ADDENDUM NO. 1

PROJECT TITLE: Parker Park Community Center Pool Addition
City of Jonesboro
Jonesboro, Arkansas

COMMISSION NUMBER: 2301

DATE OF ISSUE: August 18, 2023

M101

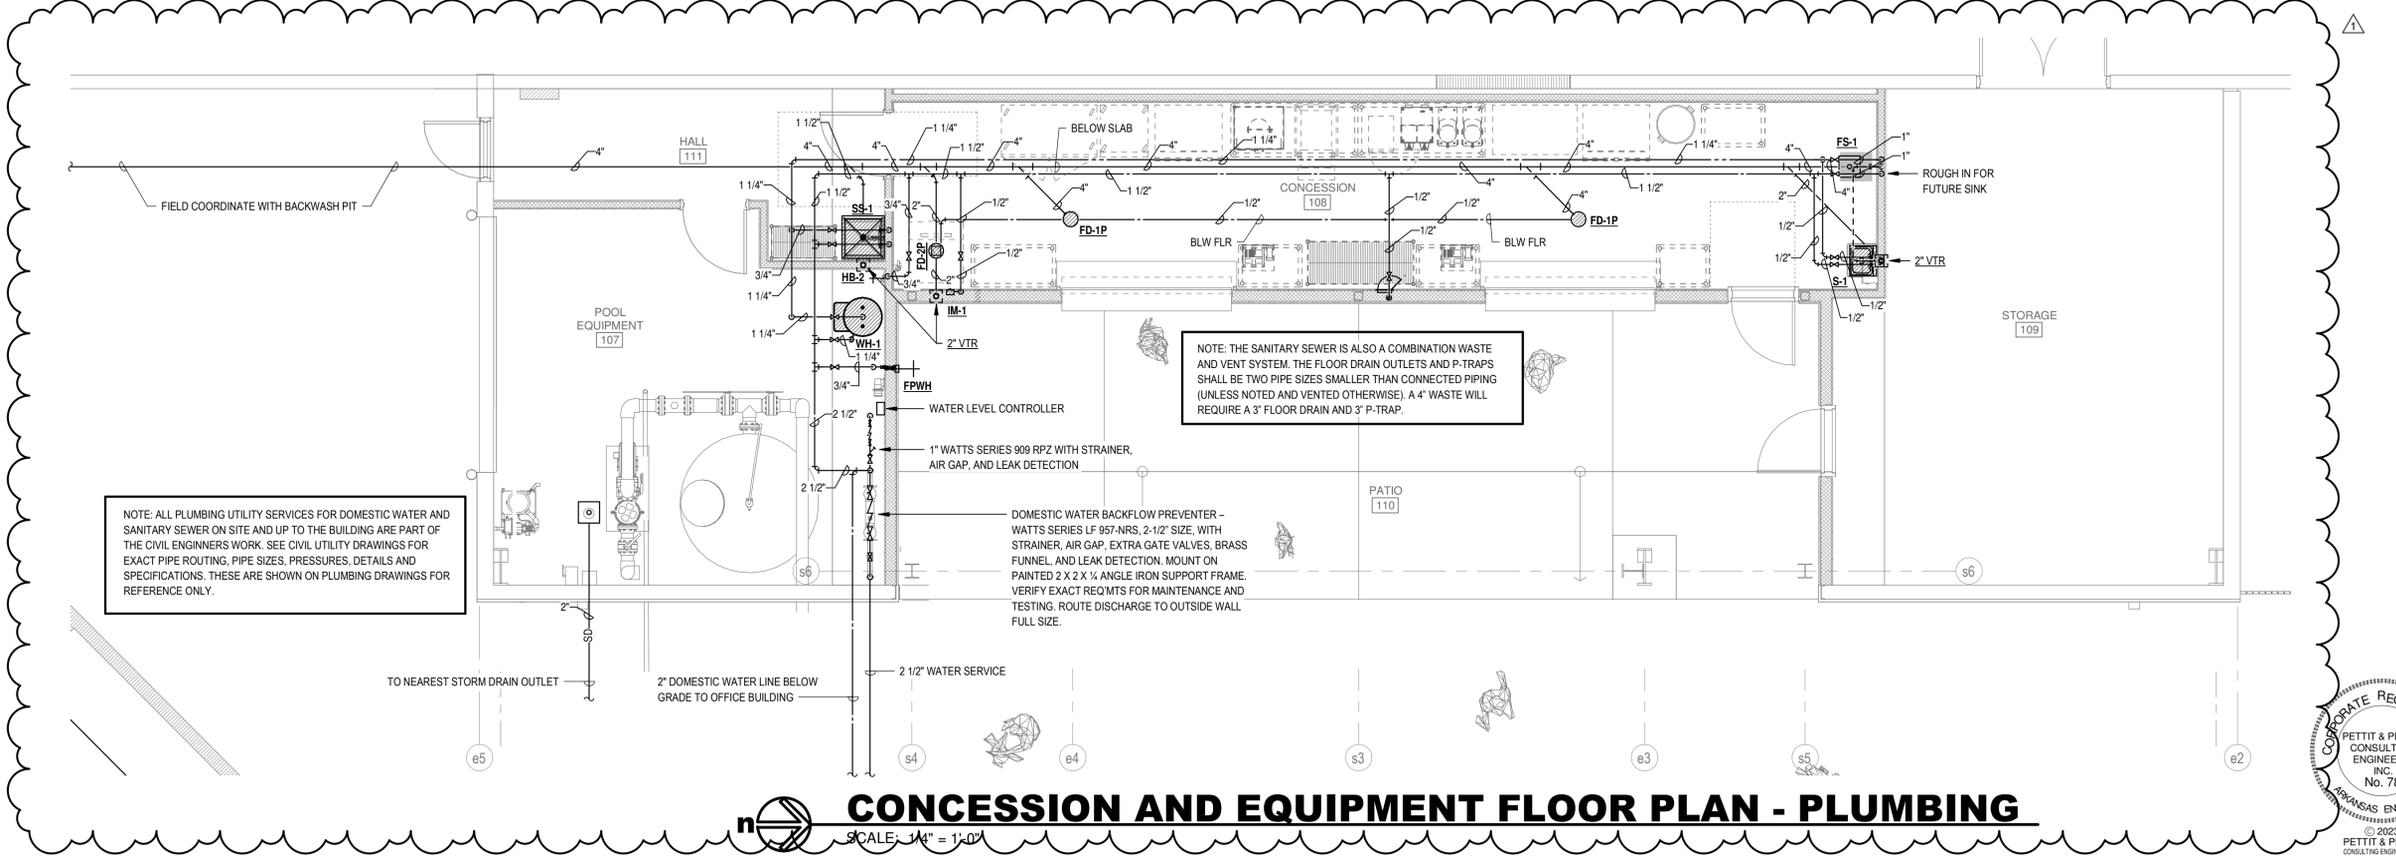
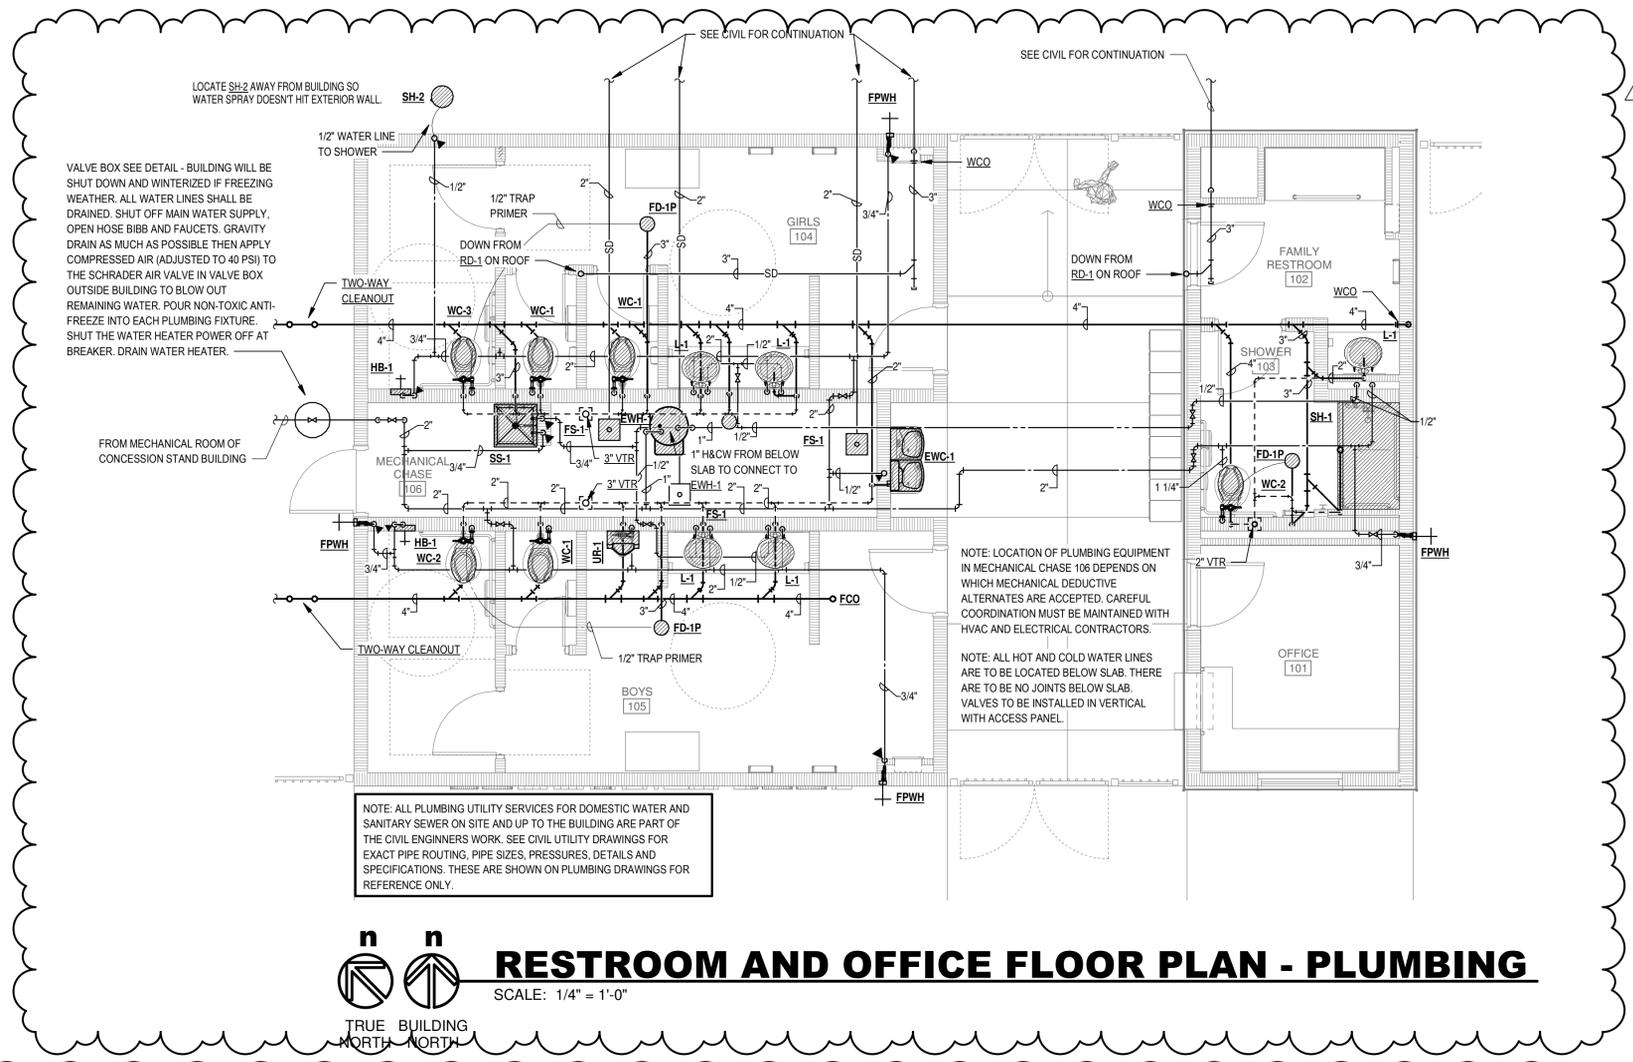
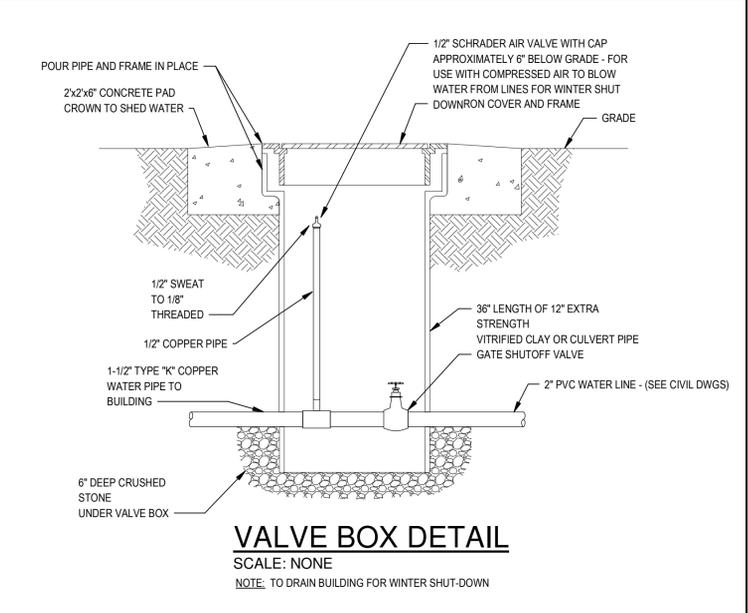
19. Drawings: Sheet M101- Floor Plans - HVAC

- A. Omit Sheet M101 in its entirety. Replace with attached Sheet M101 dated 08.04.23. Refer to page 41 of this addendum.

E101

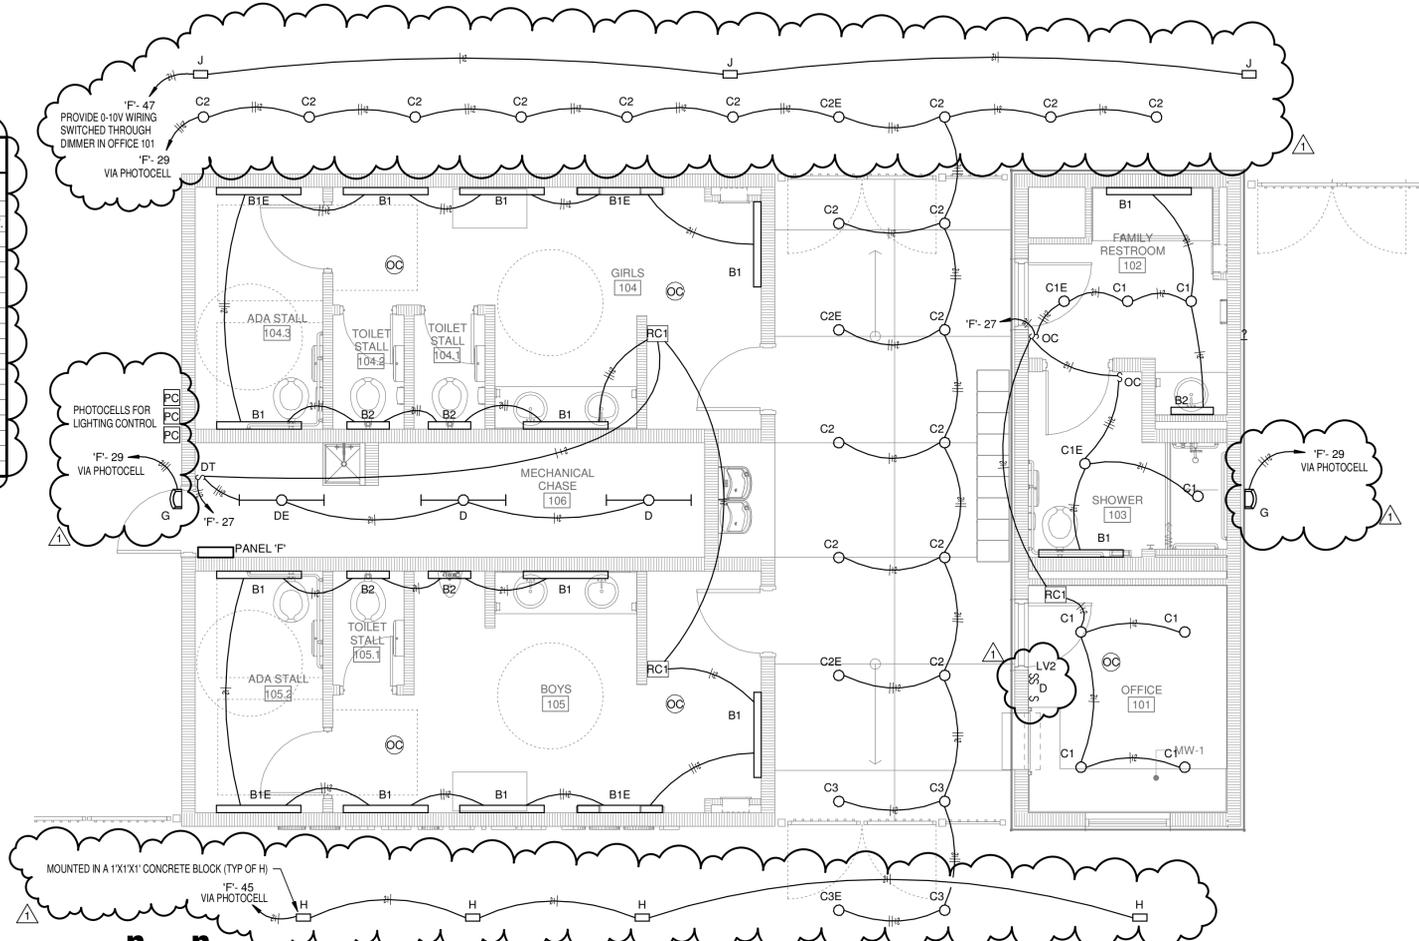
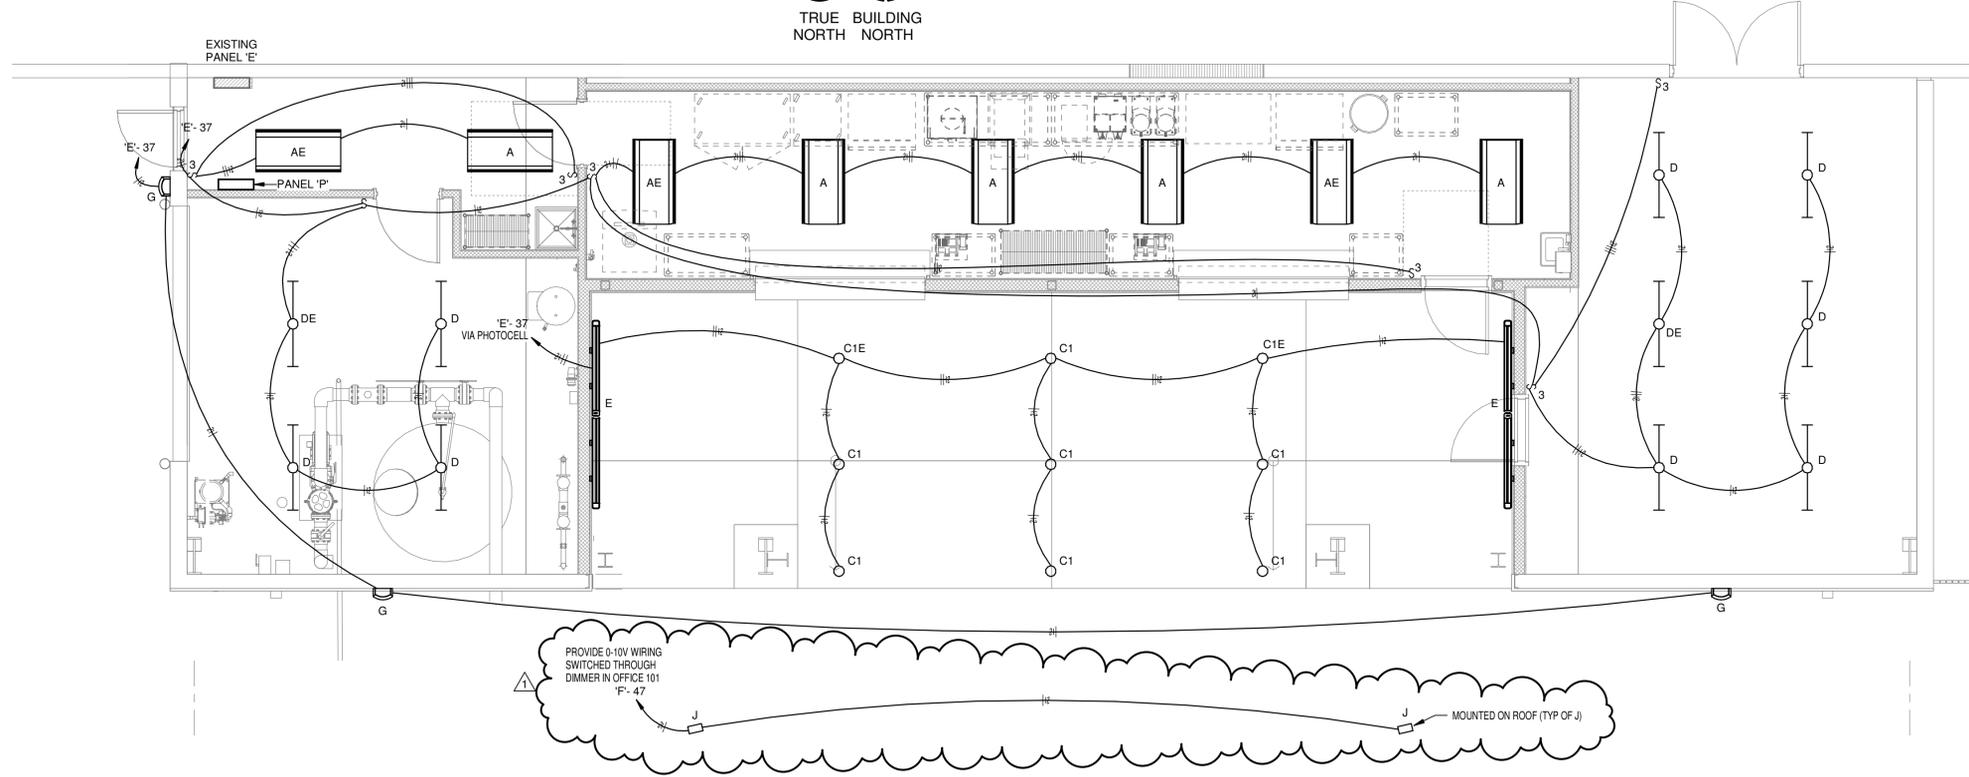
23. Drawings: Sheet E101 – Floor Plan - Lighting

- A. Omit Sheet E101 in its entirety. Replace with attached Sheet E101 dated 08.04.23. Refer to page 45 of this addendum.

E102

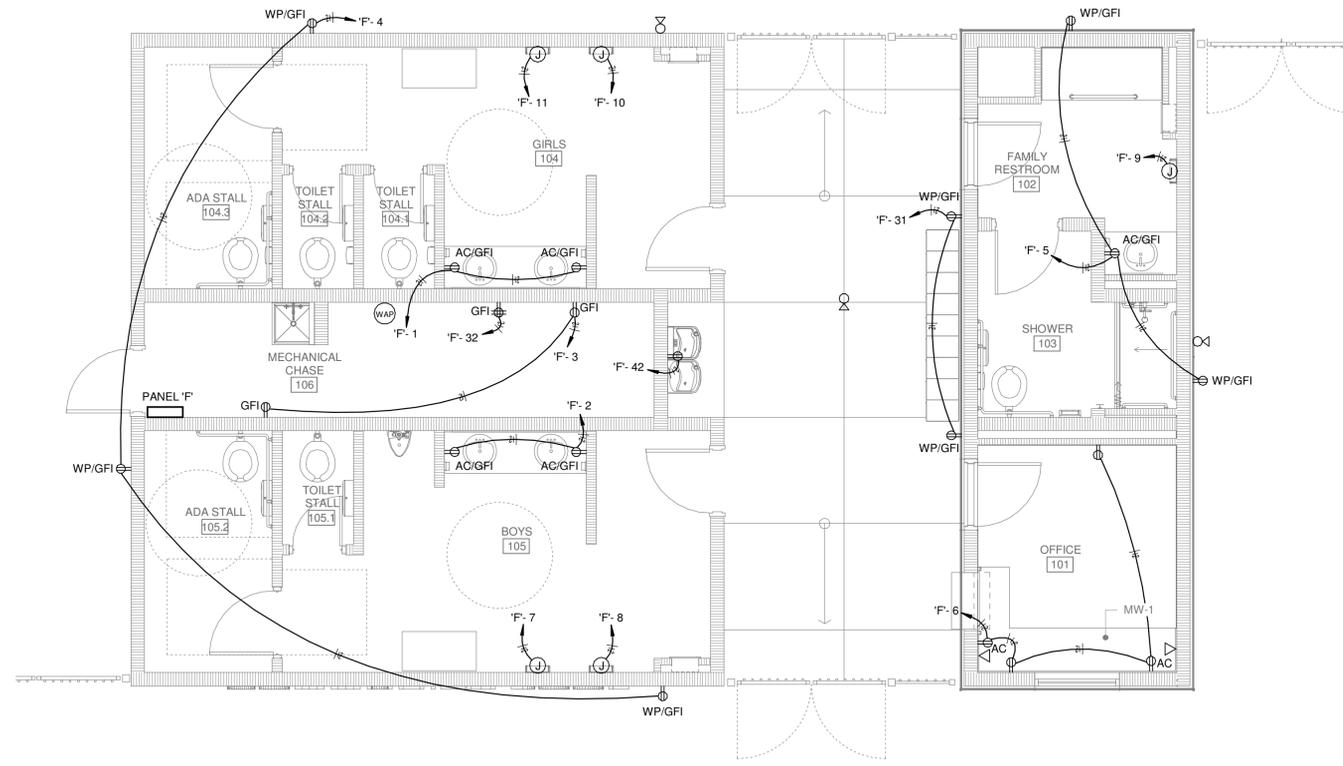
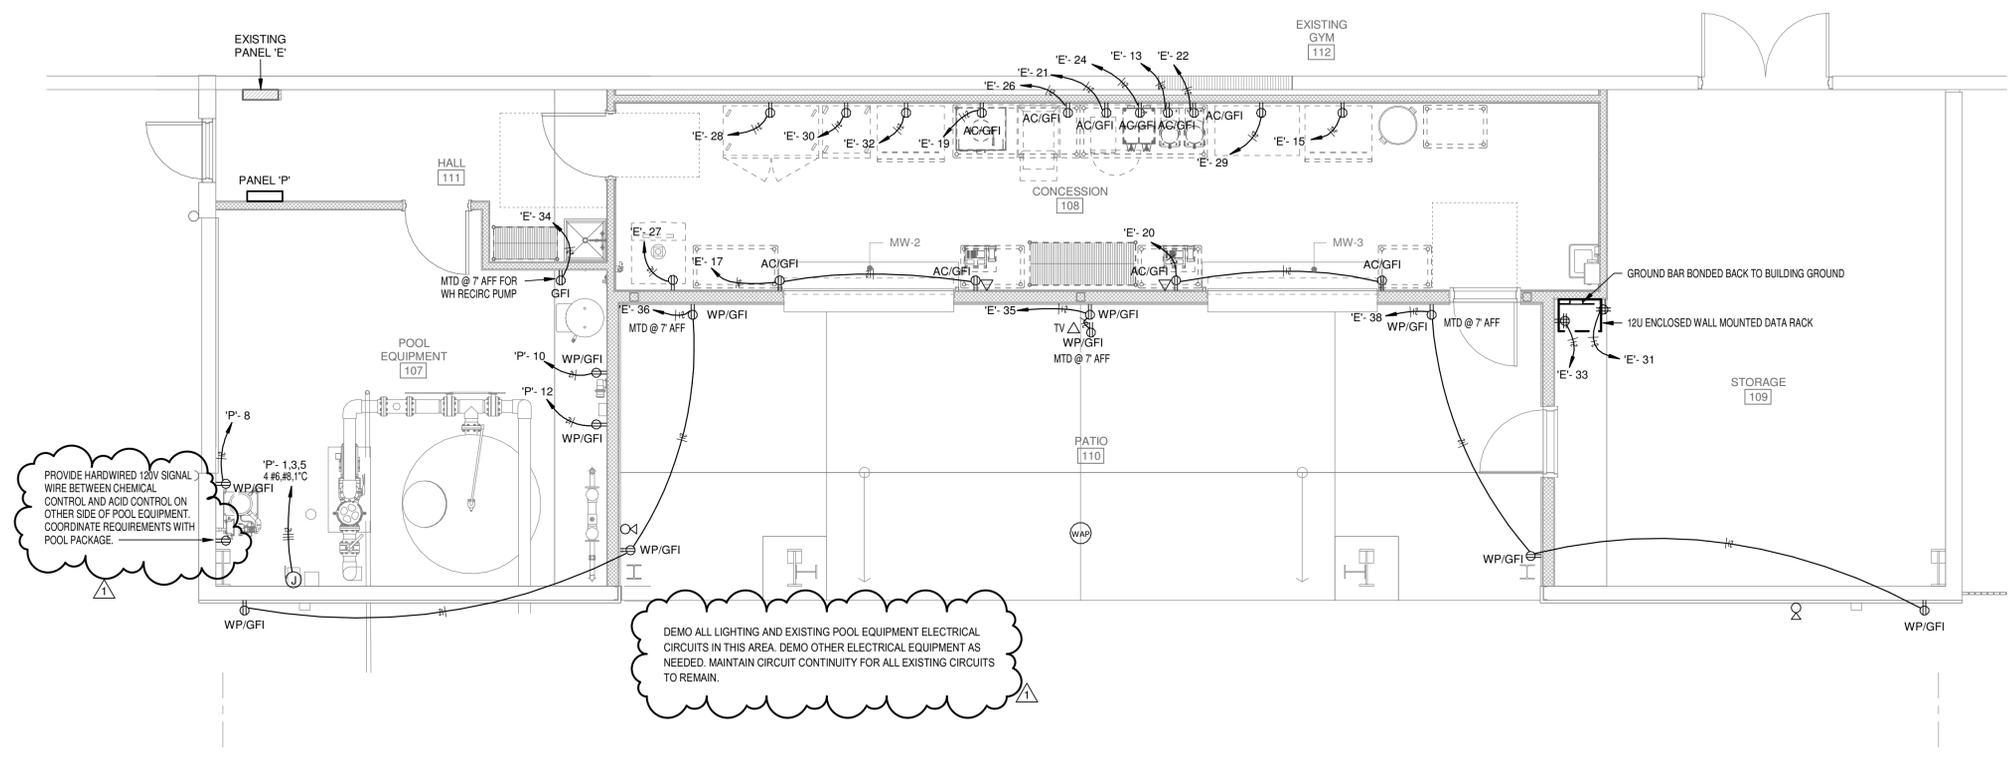
24. Drawings: Sheet E102 – Floor Plan - Power

- A. Omit Sheet E102 in its entirety. Replace with attached Sheet E102 dated 08.04.23.
Refer to page 46 of this addendum.
